May 29, 2020

Re: Case No. ENV-2018-2116-EIR
Project name: Hollywood Center Project
Comments on Draft Environmental Impact Report

Figure 1 – Veneklasen Receptor Location Map

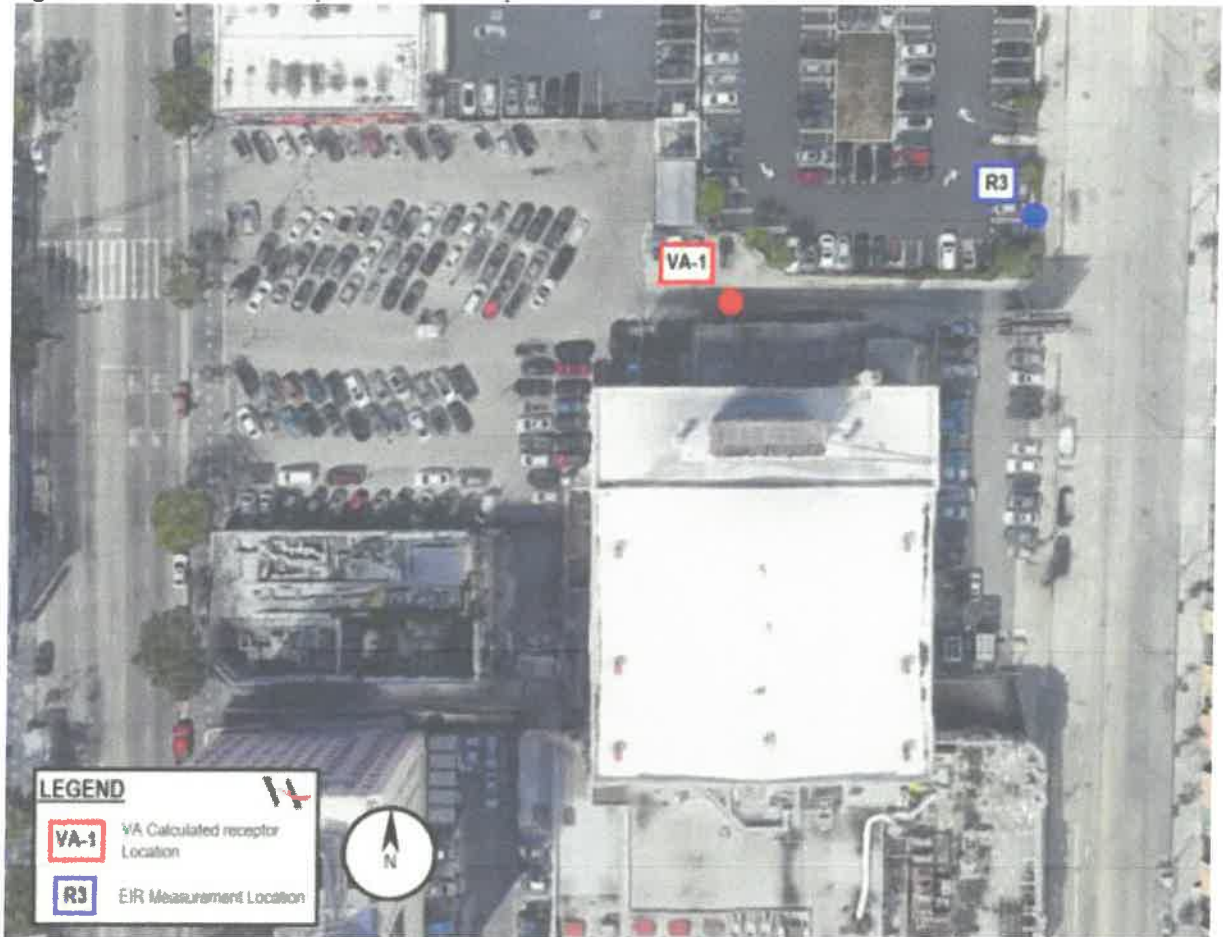
Draft EIR Page IV.I-21, Table IV.I-5: The measured noise level at measurement position R3 is not representative of the noise levels at the back of the Pantages Theater. The measured ambient level for the Pantages Theater indicated in Table 1, Appendix K-2 states that the measured level is 60.1 dBA at R3 along Argyle Avenue. This is not representative of the sound levels in the access alley behind the theater where there is some exposure to Vine Street, but also significant acoustical shielding because of building geometry which does not appear to be accounted for. Veneklasen performed a distance and angle attenuation analysis at Veneklasen receptor location VA-1 which is shown in **Figure 1**. Using the measured level at R3 along Argyle Avenue and the measured level at R2 on Vine Street, Veneklasen calculated the ambient noise level at VA-1 to be approximately 56 dBA, accounting for increased distance and reduced angle of exposure. As such, the significance thresholds identified in Table IV.1-19 and Table IV.1-10 for the Pantages Theater (receptor location no. 9) are significantly higher, which has the effect of understating the impact of construction noise on the Pantages Theater. Additional sound level measurements should be performed of suitable duration to determine the ambient levels in the alley behind the Pantages Theater. Veneklasen would suggest a minimum measurement duration of 72 hours during normal weather conditions.

Additionally, once the subject project is constructed, the alley behind the Pantages will be completely shielded from Vine Street, and the angle of exposure to traffic noise from Argyle Avenue will be further reduced, likely causing the noise levels to decrease further. Veneklasen estimates the post-construction ambient noise level in the alley behind the Pantages Theater to be approximately 47 dBA.

Figure 2 – Background Music Distance Attenuation Locations

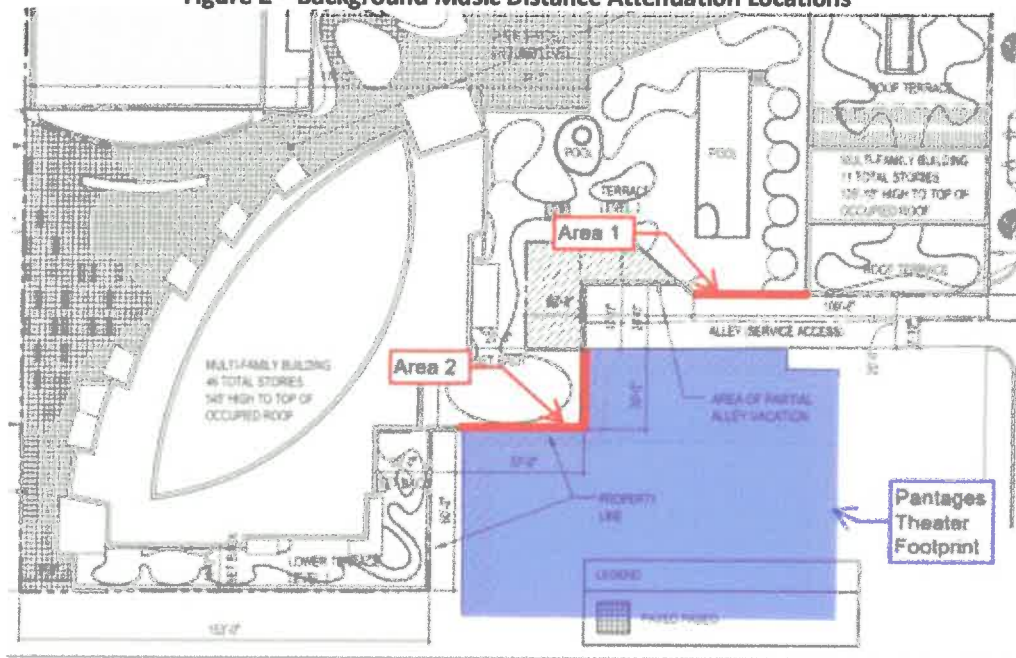
Draft EIR Table IV.I-12 and Page IV.I-51: On page IV.I-51 it is stated that the “sound level of the music speakers is conservatively assumed to be 75 dBA at 25 feet, which is more than 5 dBA higher than the ambient noise levels in the vicinity of the Amenity Deck (Level 2), East Site, which ranges from approximately 60.1 to 68.3.” The predicted noise level pre-construction is 56 dBA and as stated in **Item I** above, Veneklasen predicts the post-construction noise level from Argyle Avenue to be about 47 dBA. Both predicted pre-construction and post-construction noise levels are significantly lower than the assumed 60.1 stated in the Draft EIR indicating that additional review and analysis should be performed. The areas from which Veneklasen performed a distance loss calculation between the Amenity Deck (Level 2), East Site and the Pantages Theater are shown in **Figure 2** below:

The distance from Area 1 to the Pantages Theater is 20 feet and the Distance from Area 2 to the Pantages Theater is 0 feet. For the purpose of an accurate analysis, Veneklasen has assumed a minimum distance of 5 feet from the nearest music speaker for Area 2. The results of these calculations are shown in **Table 3** below:

Figure II-19 indicates that under the East Site Hotel Option, there will be a swimming pool located in Area 2 is as shown in **Figure 2** above. Using the same calculation methods to determine the sound levels from speech at the Pantages from this area, the noise level will be 80 dBA at the Pantages. This would be a significant on-going impact and this area cannot be occupied by a pool, as any operation will significantly exceed both proposed interior noise guidelines and could negatively impact rehearsals and other theater operations.

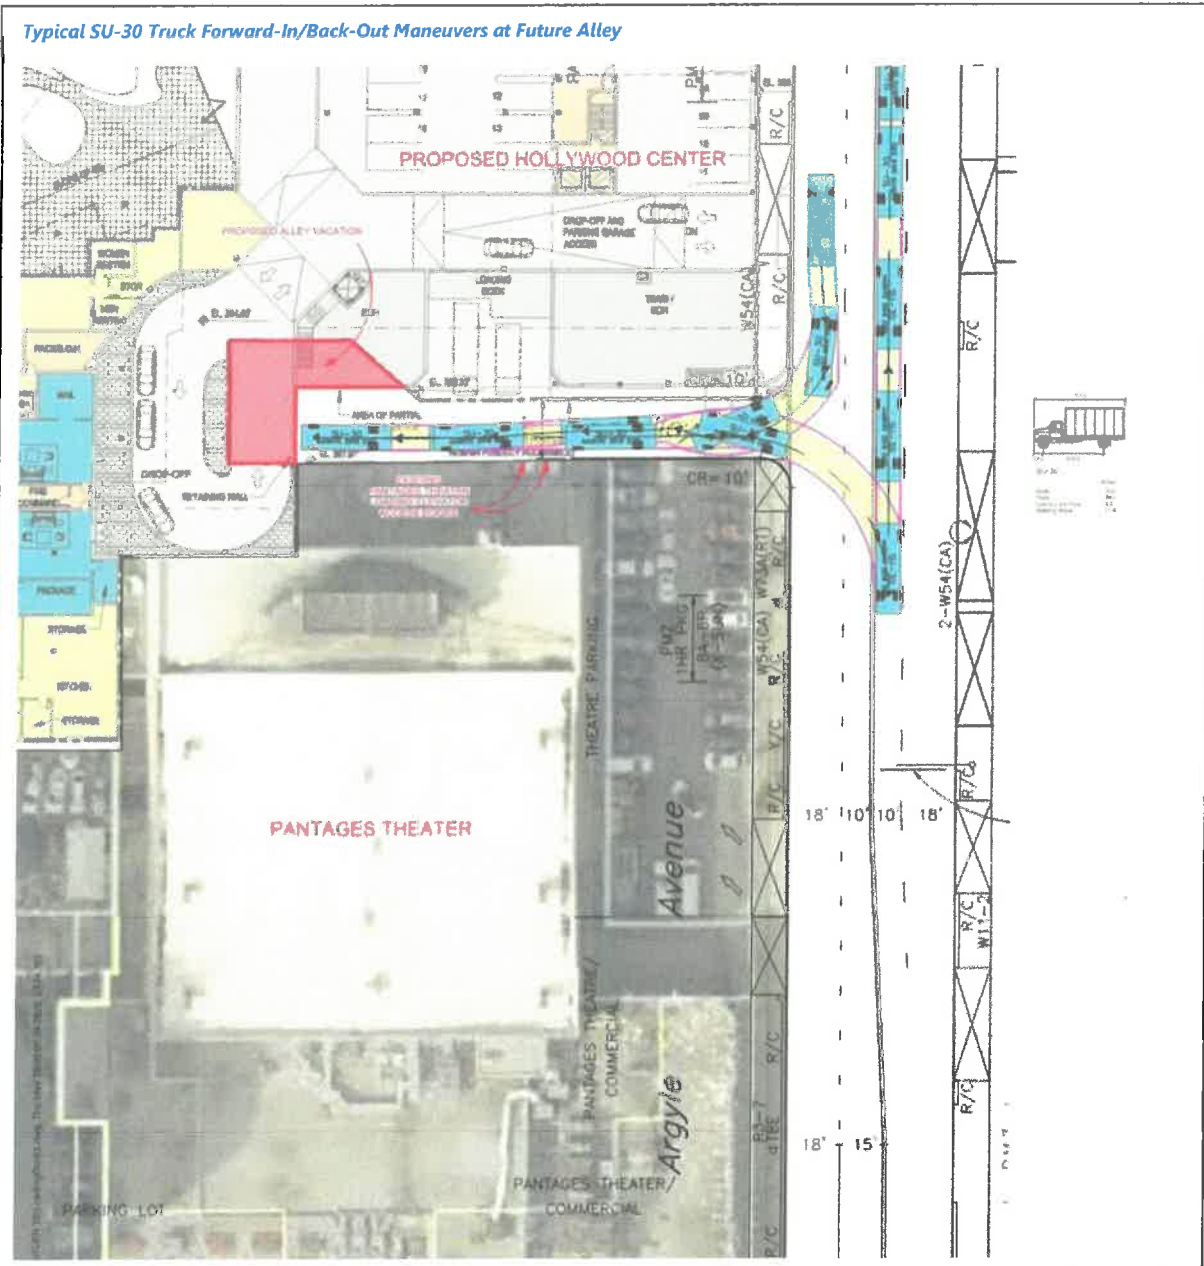
Figure 2D, which indicates that Project drop-off/pick-up area will occupy the vacated portion of the alley, is consistent with Figure II-14 in the Description of Project section of the DEIR, which indicates that this vacated portion of the alley is to have walls constructed separating it from the remaining alley, thus creating a dead-end condition for the shared alley with no turnaround space for service trucks. The alley turnaround area is currently used for daily delivery trips by the Pantages Theatre, trash pickups, and other services, and needs to remain usable without impedance. Under the existing conditions, standard single-unit trucks (SU-30) can utilize the turnaround area to depart without having to back out of the alley:

Under the proposed conditions, a typical SU-30 truck will no longer be able to turn around in this dead-end alley, and must back out of the alley driveway in order to depart, thereby adding even more truck movements on Argyle Avenue. Below is a typical scenario in which a SU-30 truck would have to maneuver in order to arrive and depart the alley:

- Widen and redesign the Project loading dock and the shared alley for both the Project and the Pantages Theatre so as to provide sufficient width turnaround for daily delivery vehicles, and with adequate flare at the driveway connection to Argyle Avenue to accommodate large semis to access the alley and to allow daily delivery vehicles to utilize the alley simultaneously with the presence of a parked semi in the alley. This is required for safe access as well as continued operations of the existing uses, which is critical for the Pantages Theatre. Without an adequate alley width and flared corner conditions at the northeast corner of the alley, the loading and unloading of the Project at its currently proposed loading dock would highly disrupt the operation of the Pantages Theatre. Conversely, Trucks serving the Pantages Theatre in the Alley would also render the currently proposed Project loading dock inaccessible. If either operation defaults to the effort to mutually accommodate each other's access of an inadequately designed alley and loading dock configuration, the service vehicles waiting for access would generate further disruption and congestion on Argyle Avenue in this block.

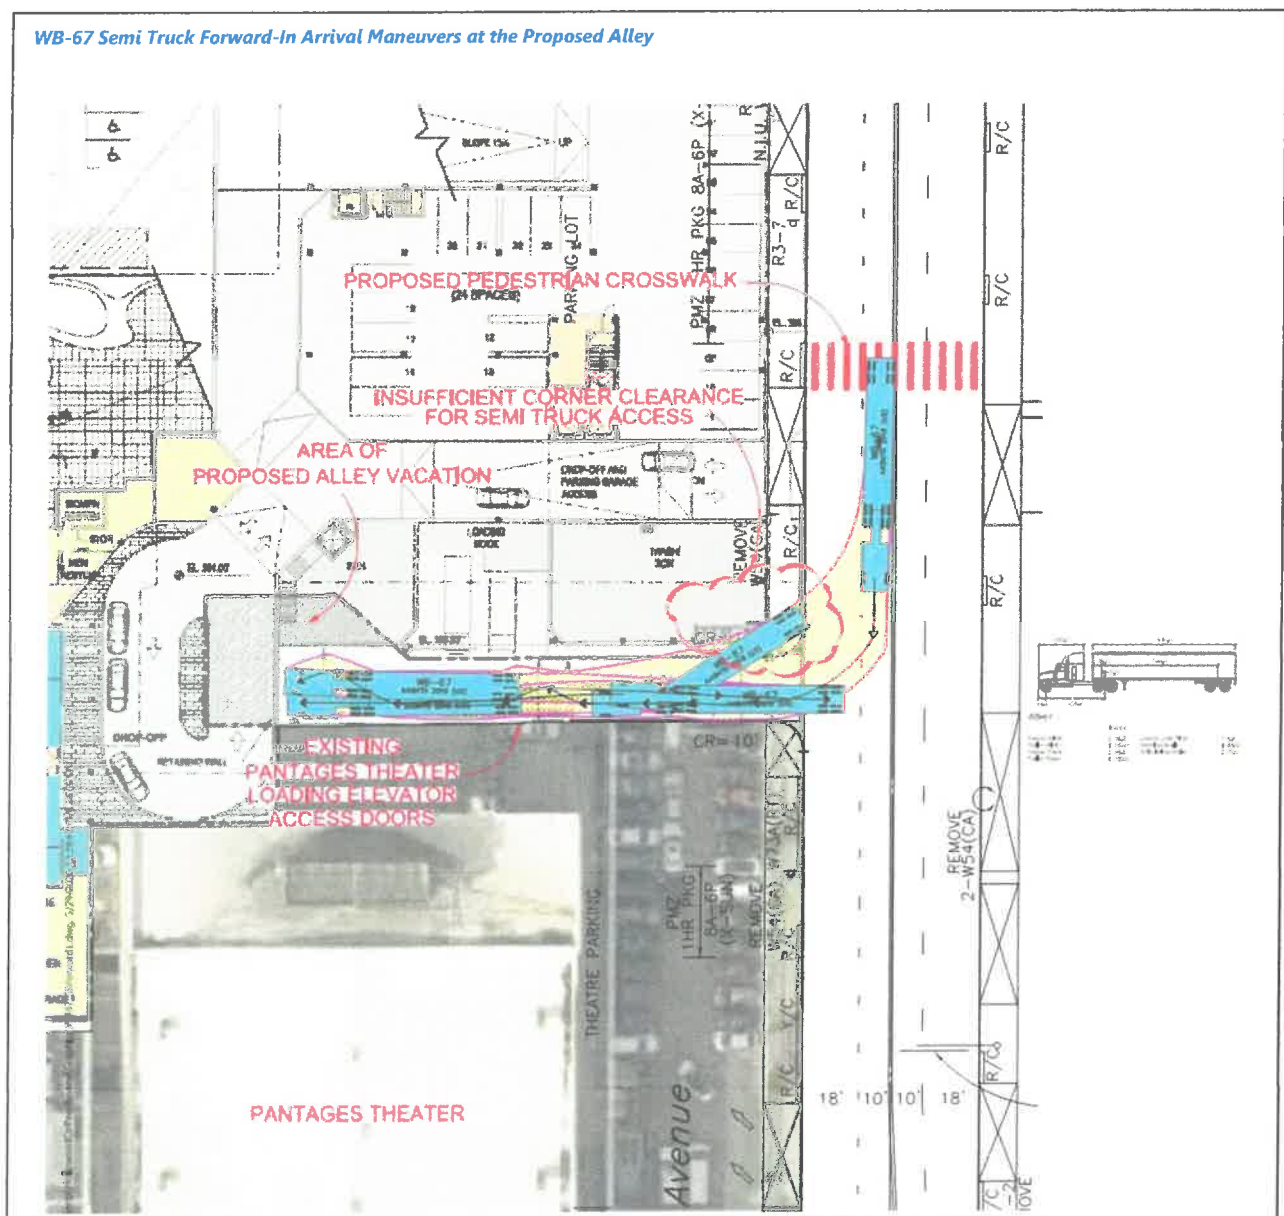
The safety concerns of requiring daily delivery trucks for the Pantages and other south side users of the alley to now back out rather than turn around needs to be analyzed and fully addressed. The analysis needs to consider having the trucks back up past the Pantages elevator and other alley activities, across the

sidewalk with sight distance for all modes (especially pedestrians), and onto Argyle Avenue with an existing parking garage entrance/exit across the street serving the Eastown mixed use development and even heavier traffic flows than the Pantages Theatre, as well as a loading dock serving the commercial uses such as CVS Pharmacy and more.

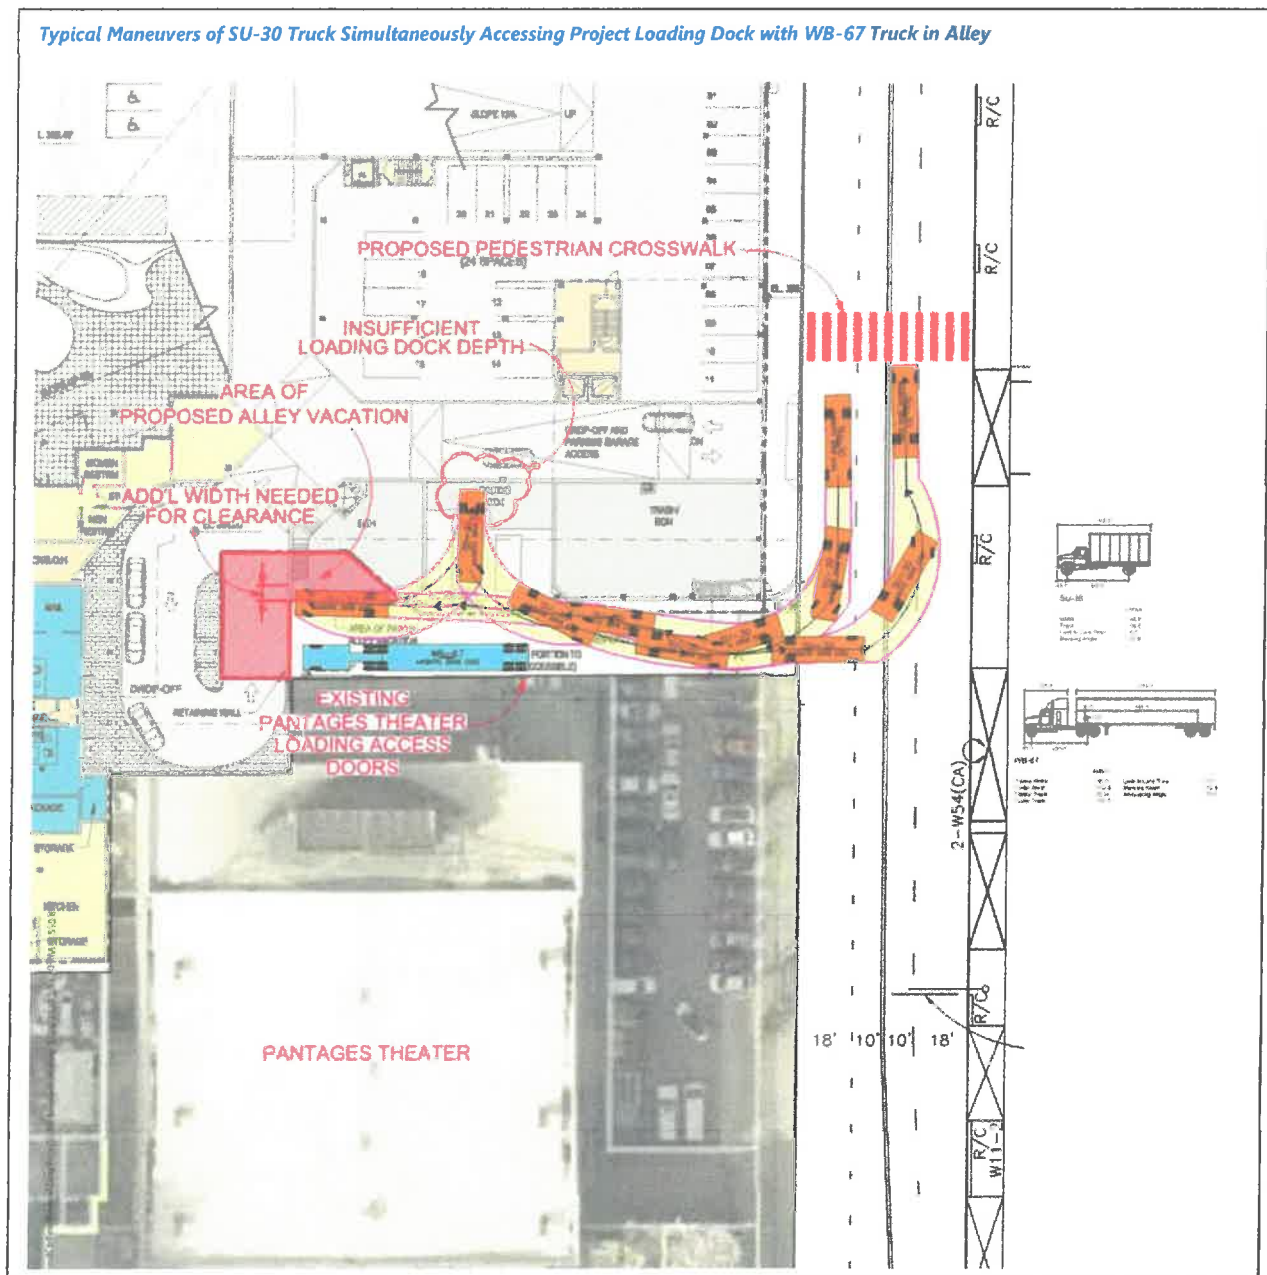
Below is a typical truck turn simulation for an AASHTO standard "WB-67" semi truck (73.5' bumper-to-bumper in length) maneuvering within the proposed alley limits for a forward-in and back-out scenario. The need for local delivery trucks to back out onto the street is exacerbated by having a parking structure entrance/exit on the opposite side alley driveway on Argyle Avenue. Trucks backing out to exit north will need to back in front of this driveway. It should also be assessed if the backing trucks will conflict with use of alley with service elevator for the Pantages Theatre.

Further, when trucks serving the Pantages Theatre occupies a portion of the currently proposed alley for loading and unloading, the Project loading dock is rendered inaccessible, as it does not have sufficient depth to accommodate the simultaneous uses that can occur within a shared use alley such as this one. An example of such a condition is shown below:

As shown above, in order for a SU-30 truck to access the project loading dock while a semi truck is positioned in the alley, additional width is needed in order for the su-30 truck to bypass the WB-67 semi

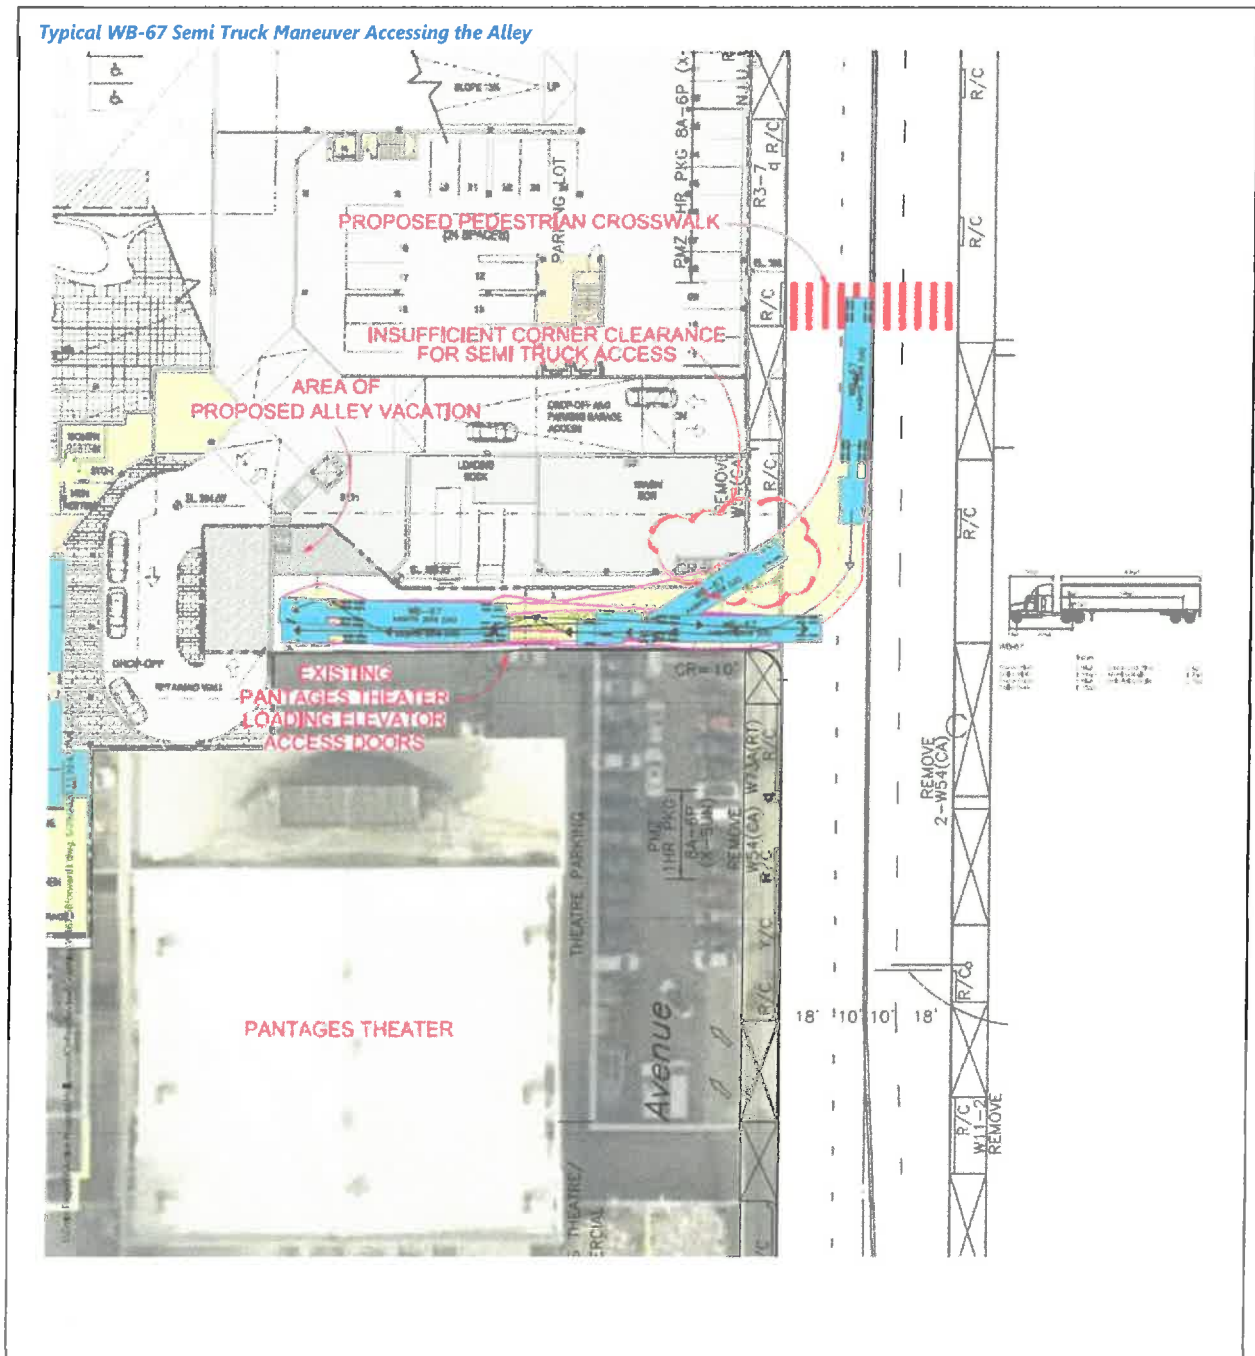
It is also noteworthy that the private driveway serving the Easttown mixed-use development (the east leg of the signalized intersection) is currently a right-in/right-out only driveway, with speed bumps and the eastern terminus of this driveway being gated and closed to through traffic:

These traffic signage were installed as part of the Easttown development at the request of LADOT. Typically, LADOT imposes left turn prohibitions to private driveways as a tool to reduce the amount of additional traffic added to an already congested roadway, or as a means to reduce the probability of potential traffic safety conflicts in that specific location. Vehicles exiting the Easttown driveway making left turns into a gridlocked traffic condition may block northbound traffic from flowing through while waiting for a gap in the southbound traffic. While common wisdom may deduce that having a signalized intersection that serves both the Project and the Easttown driveways would alleviate these concerns, the introduction of a new traffic signal will cause further delays on Argyle Avenue, as it will increase wait time. A comprehensive queuing and signal timing synchronization study, along with safety, and neighborhood traffic management analysis of Argyle Avenue and the Project driveway should be conducted, as queuing will be an added issue for a full signal with phases activated by automobiles exiting either driveway.

Based on those considerations, the following statement on Page 123 is not correct:
